# Supplementary Note for the Changes of Development Traffic Generation and the Changes of Parking Provision

The report of the Traffic Impact Assessment (“TIA”) for Section 16 Planning Application (No. A/YL-NSW/314) was accepted in principle by the Transport Department (TD) in October 2023. However, in order to meet with the Agriculture, Fisheries and Conservation Department’s (AFCD) comments on the proposed wetland area, amendments to the original Master Layout Plan (MLP) and development parameters (the revised MLP scheme) have been made accordingly as presented in **Annex A**.

Project Title  
**PLANNING APPLICATION FOR PROPOSED COMPREHENSIVE DEVELOPMENT SCHEME TO INCLUDE WETLAND RESTORATION PROPOSAL AND PROPOSED FILLING OF PONDS/LAND AND EXCAVATION OF LAND IN "OU(CDWRA)" ZONE AT VARIOUS LOTS IN D.D. 104, NORTH OF KAM POK ROAD EAST, POK WAI, YUEN LONG, NEW TERRITORIES**

Revised MLP Scheme  
Figure 2.1a

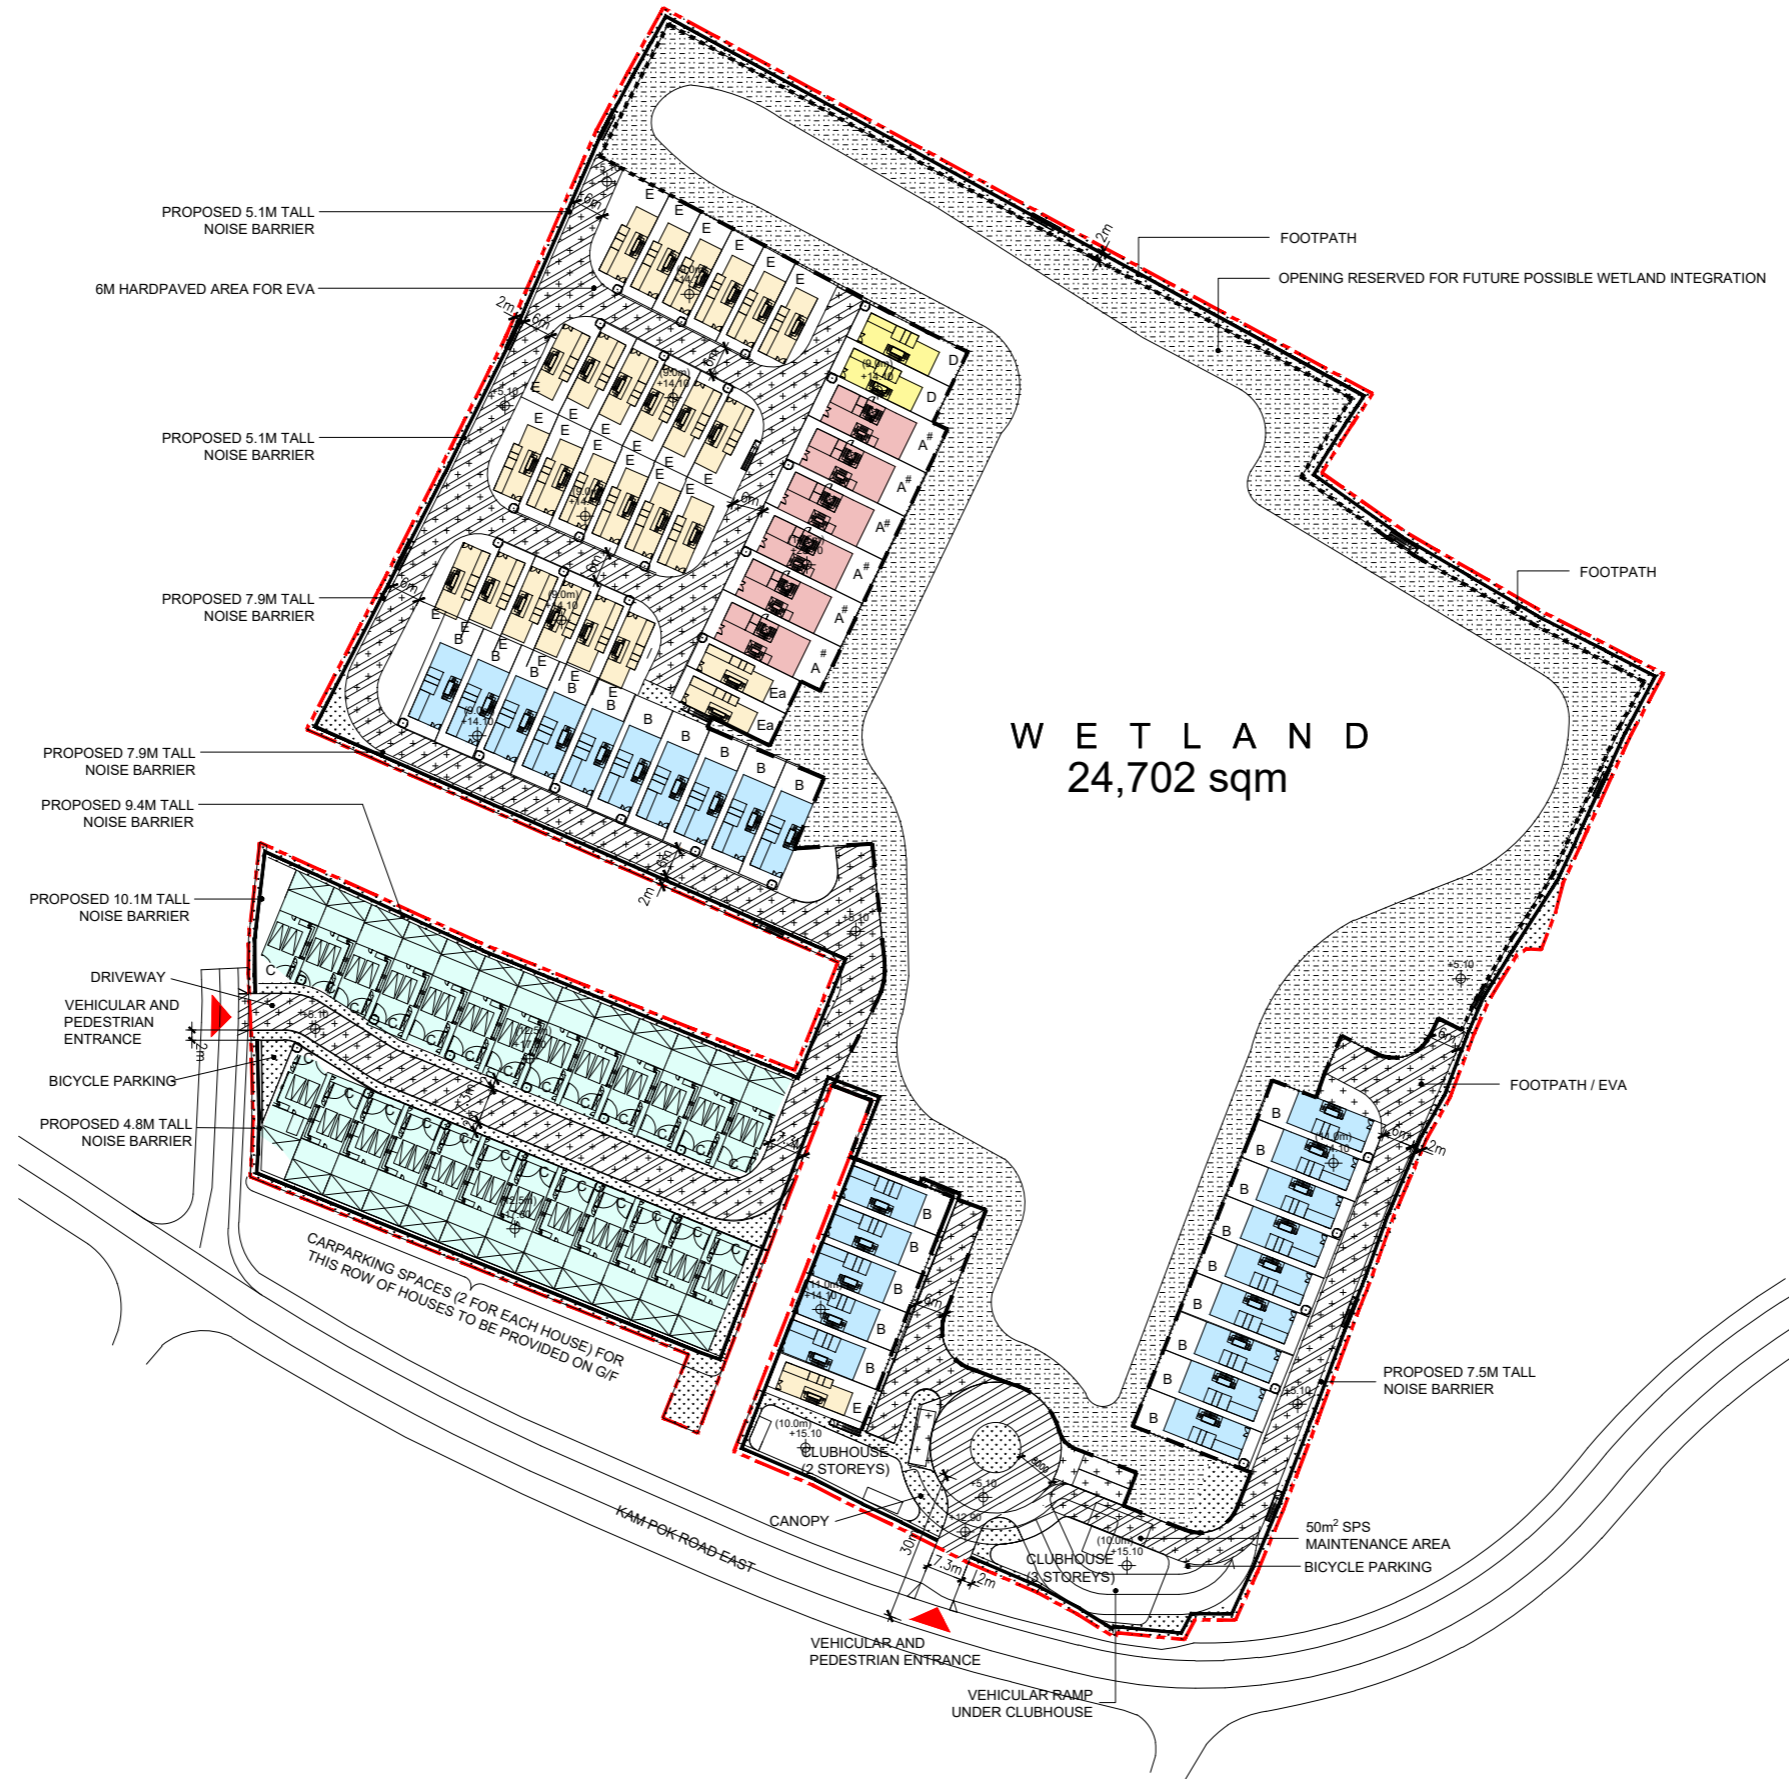
Under the revised MLP scheme, the proposed number of residential units will be reduced by 23 units, i.e., from 113 units in the original scheme (**Figure 2.1**) to 90 units in the present revised scheme (**Figure 2.1a**). The total residential GFA remains unchanged. The key development parameters of the present revised scheme are summarised in **Table 1**.
